ACCESSION NBR: 8108240256 DOC. DATE: 81/08/11 NOTARIZED: NO DOCKET #: 05000389  
 FACIL: 50-389 St. Lucie Plant, Unit 2, Florida Power & Light Co.  
 AUTH. NAME: UHRIG, R. E. AUTHOR AFFILIATION: Florida Power & Light Co.  
 RECIP. NAME: EISENHUT, D. G. RECIPIENT AFFILIATION: Division of Licensing

SUBJECT: Forwards addl info & responses to NRC questions for SER. Responses will be incorporated into future FSAR amend.

Re: St. Lucie Unit 2  
Docket No. 50-389  
Final Safety Analysis Report  
Requests For Additional Information

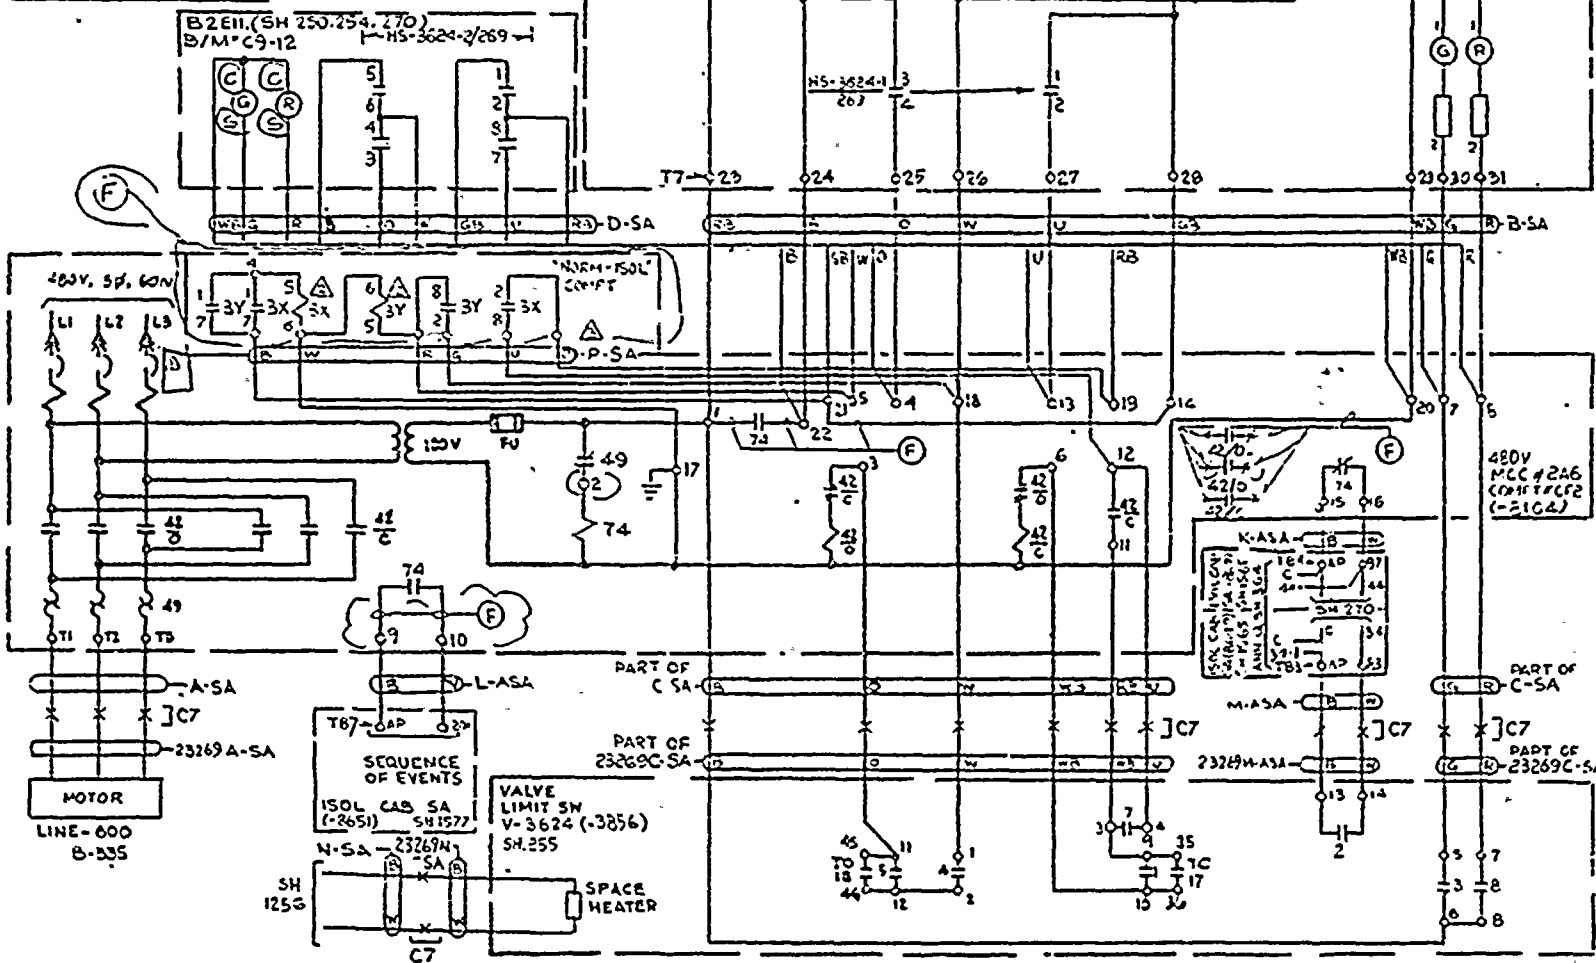
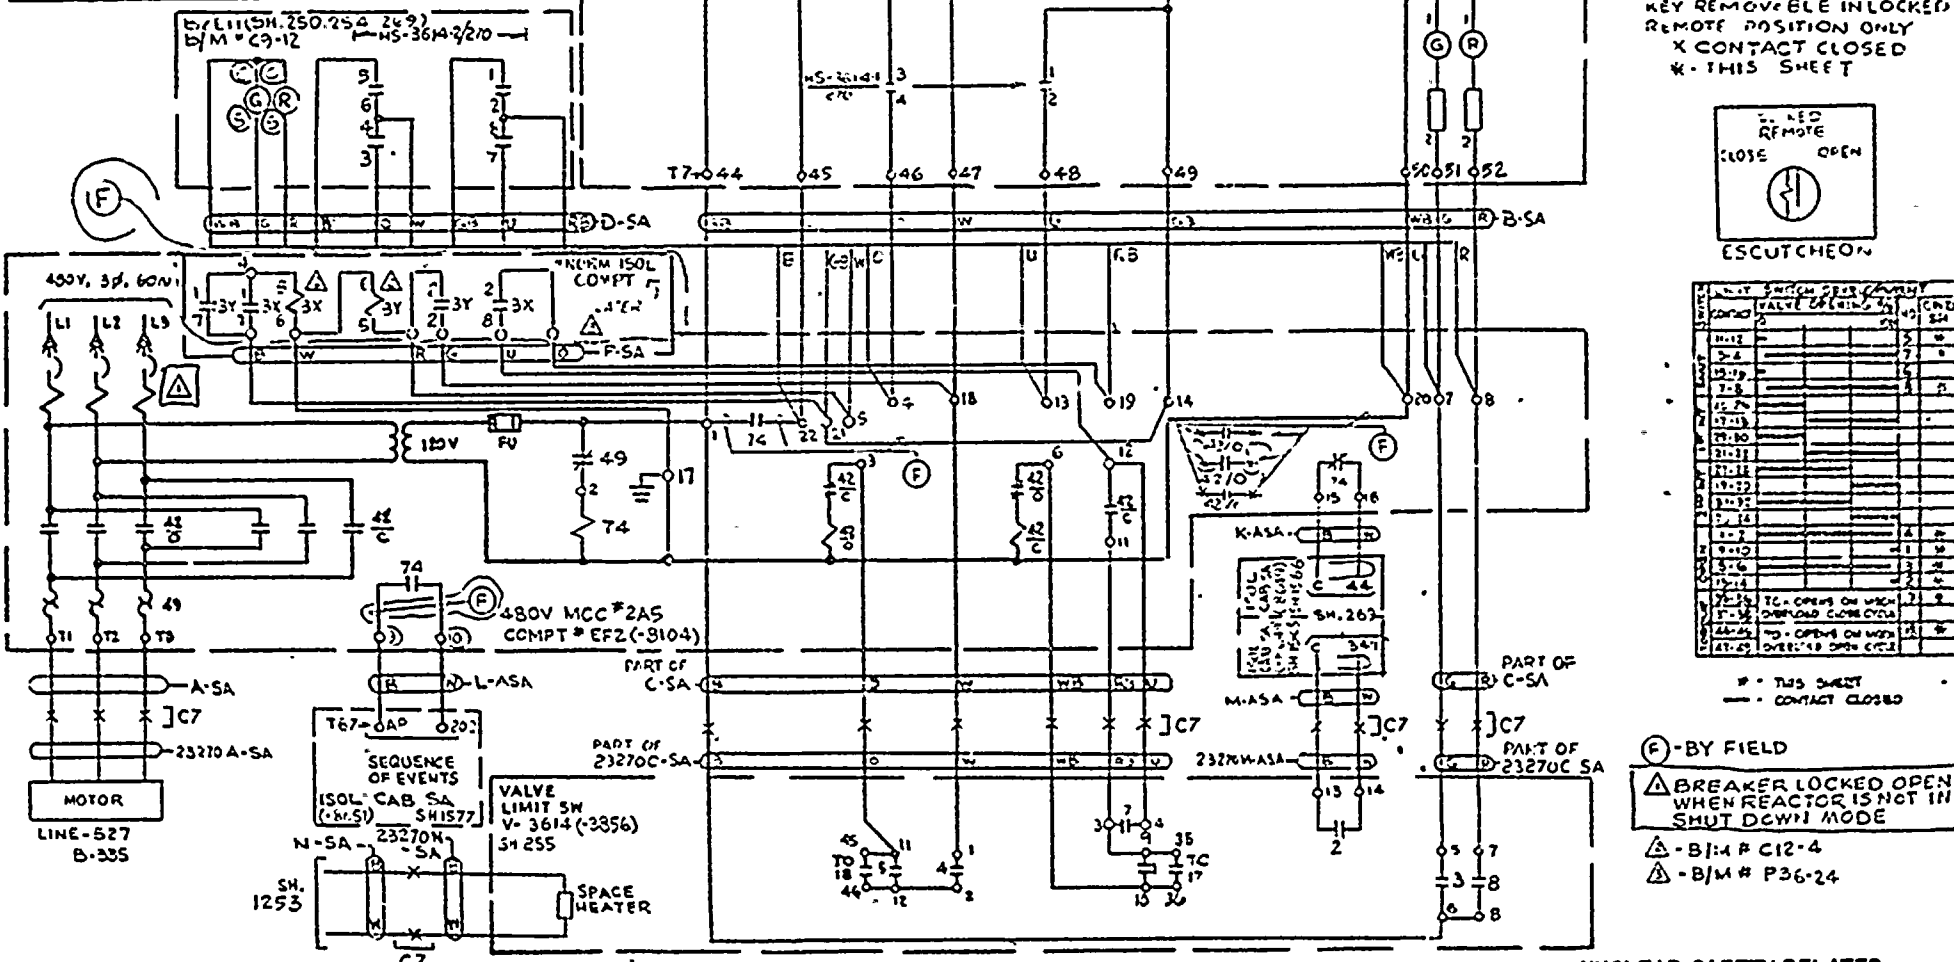
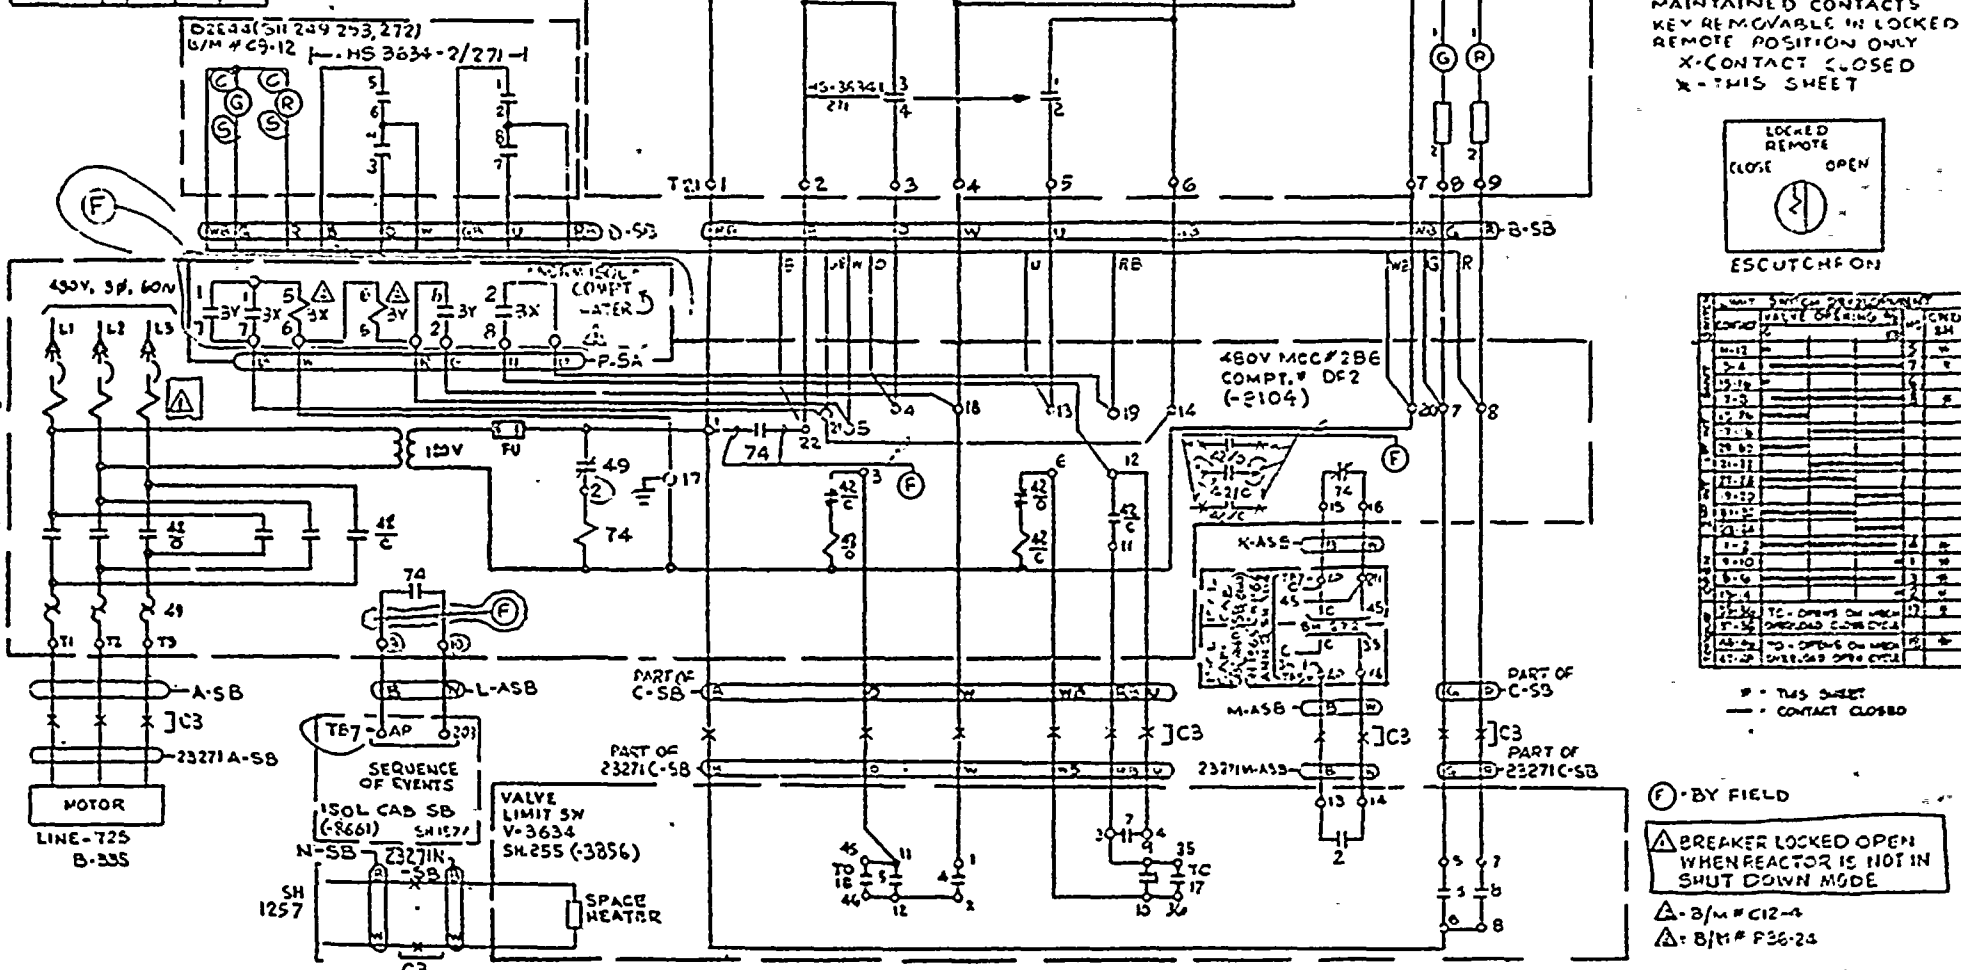
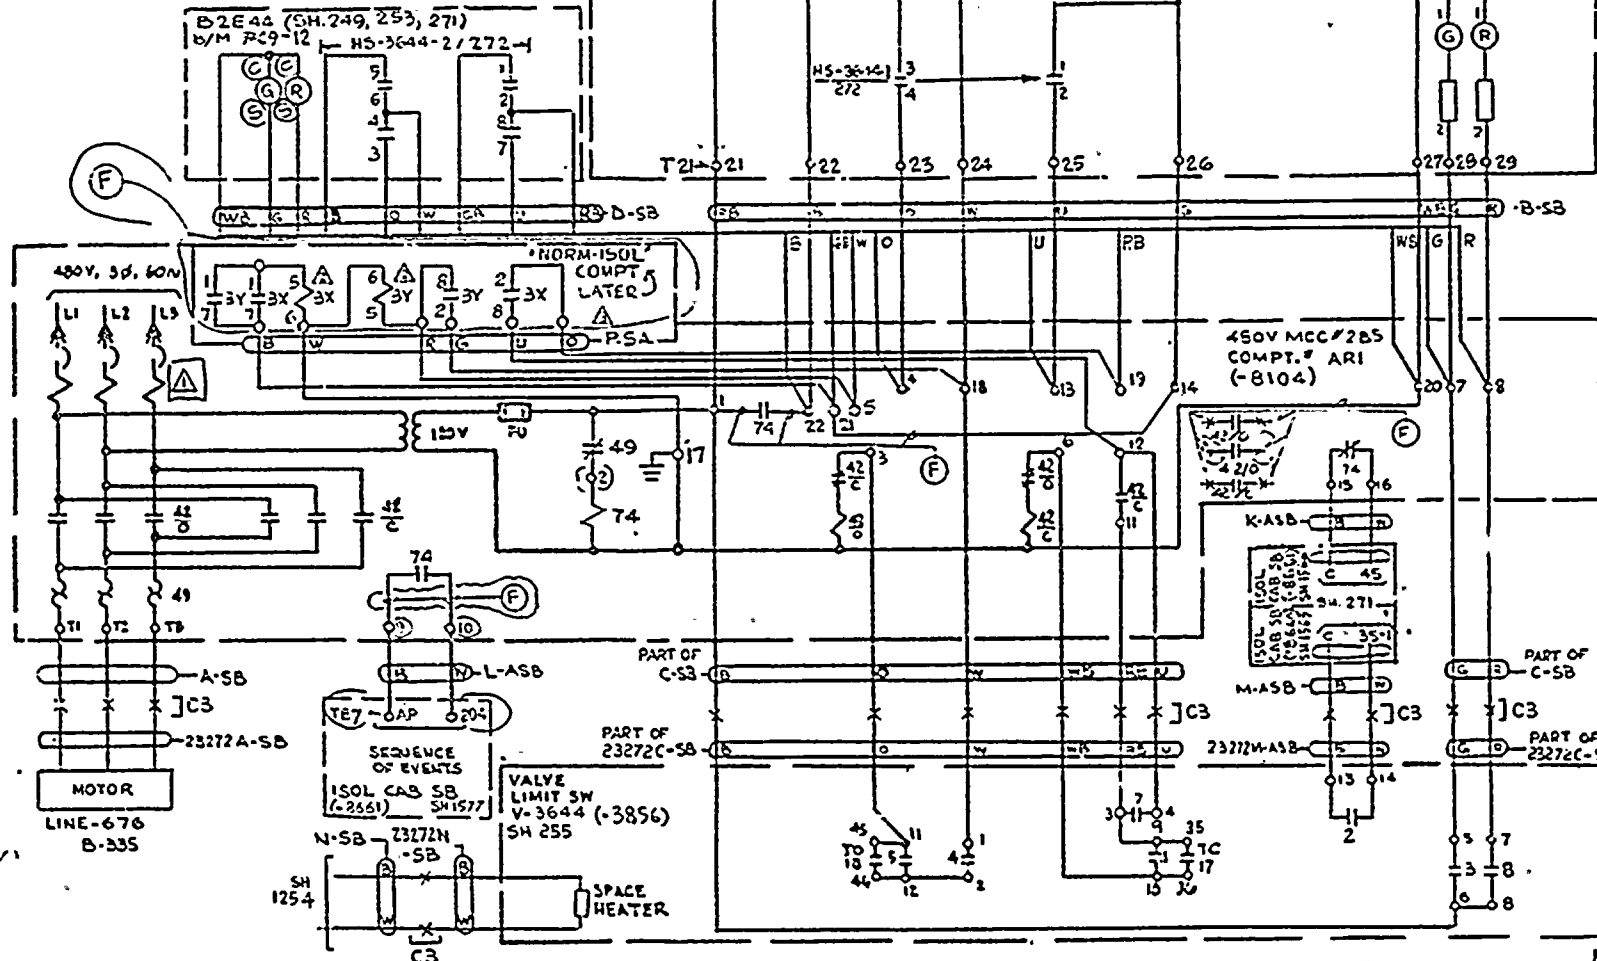
- D. Control Wiring Diagram supplied in support of the response to Chapter 8.3 open SER item on power lock out to MOV's.
- E. Response to Chapter 8.3 open SER item on isolation devices.

FIG. 6.2-9a CONTAINMENT PRESSURE - MSLB-MSIV FAILURE AT 102% POWER.

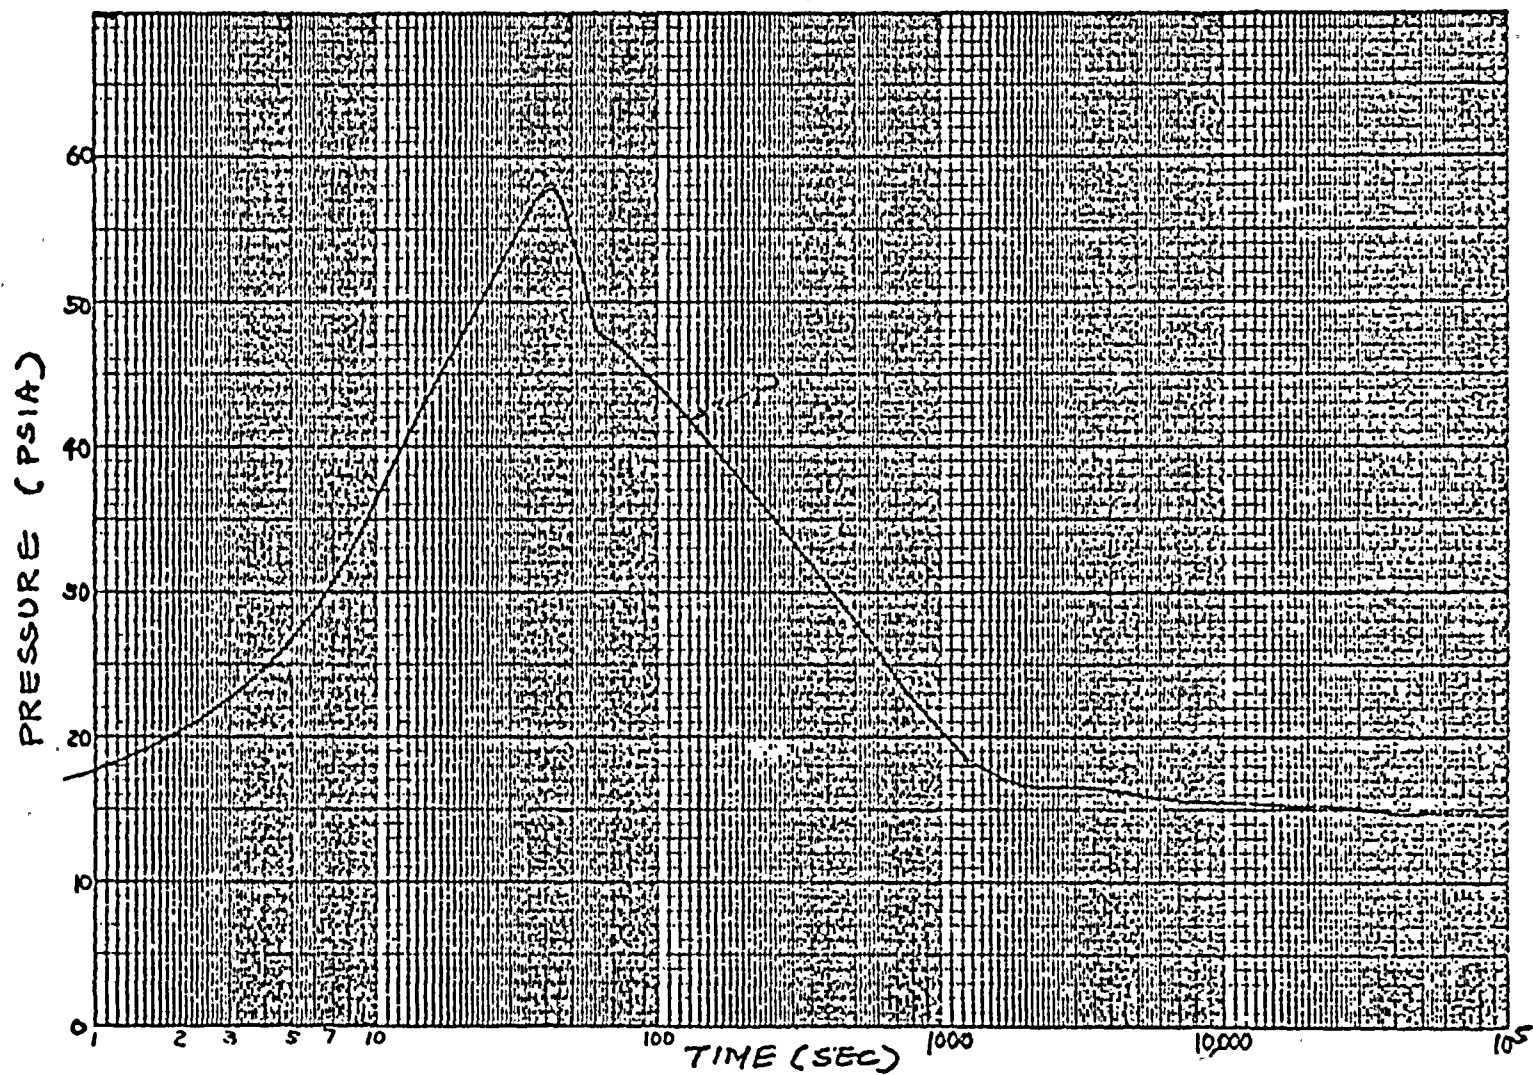
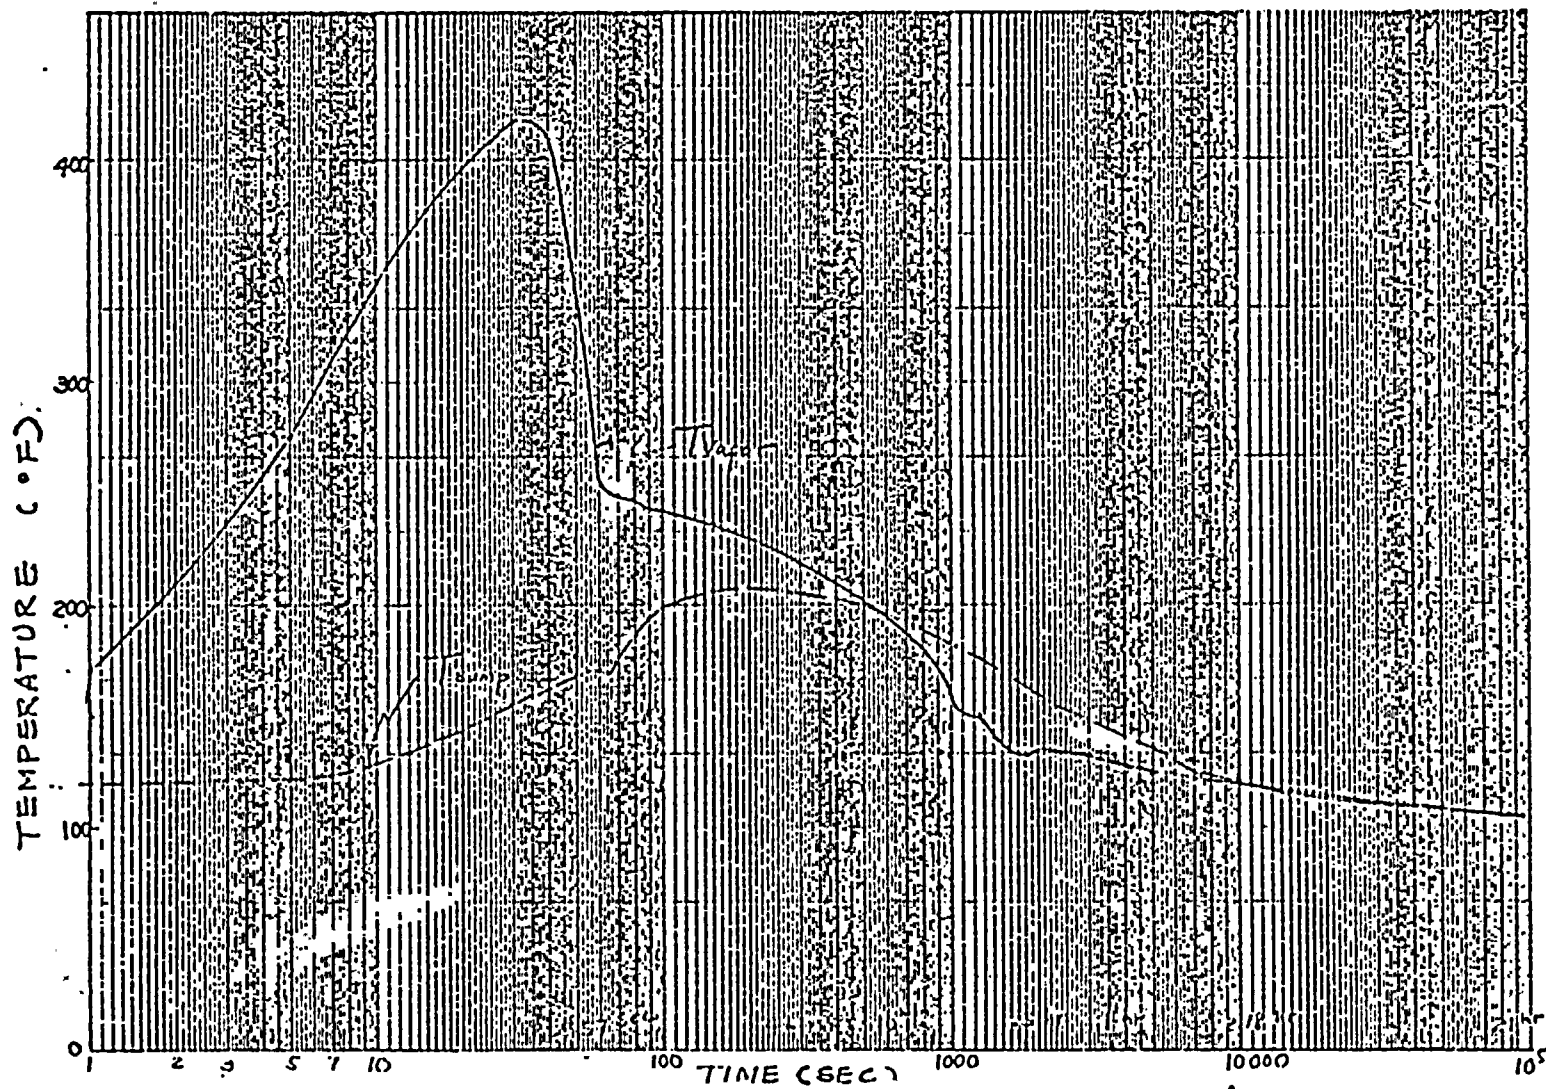
1.0 Figure 6.2-9 and Figure 6.2-10, with respect to containment pressure and temperature responses following a MSLB accident, should be revised to show the containment pressure/temperature response profiles (from time = 0 second to  $10^5$  seconds following the accident) for use in equipment qualification.

Response See FSAR revised text and new FSAR Figures 6.2-9a and 6.2-9b for containment pressure and temperature responses following a MSLB accident for the range of 0 to  $10^5$  seconds.

\* Figures 6.2-9a and 6.2-10a show the long term temperature and pressure history of the containment pressure DBA.
